Commentary

33.110.24033-110.232 Street-Facing Facades in ~~R10 through R2.5~~ Zones

Figure illustrating which stairs are subject to limit

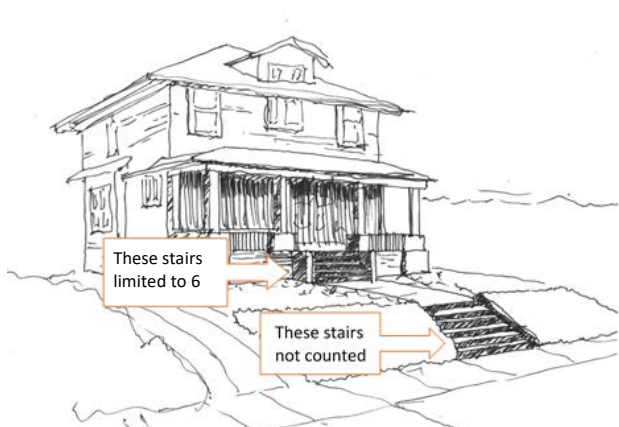
33.110.240 E. This new standard replaces the main entrance standard that previously applied only to attached houses on new narrow lots. This new standard is more broadly applicable in that it applies to any stairs located on a street facing façade. It limits the number of elevated stairs that can be used to reach an entrance. Additional steps that are built into the grade are allowed. Taller stairs on non-street facing facades are also allowed. The intention is to have a standard that is easier to understand and verify in the field than the previous standard, while limiting long, tall runs of “floating” stairways. This also improves the relationship between the first floor of the dwelling and the surrounding grade.

Houses with long runs of stairs supported by an above grade structure (middle) and ground entry (right)

Stairs on grade plus raised stairs that would be allowed

Example of a second floor entry on the front façade, which would not be allowed

3. Recessing a section of the facade by at least 2 feet; the recessed section must be at least 6 feet wide.
- E. Exterior stairs.** On any street facing facade, no more than six steps in an exterior stairway may be supported by an above grade structure. All other exterior stairs must be built into the grade. Sites located within the Special Flood Hazard Area are exempt from this standard. See Figure 110-X;
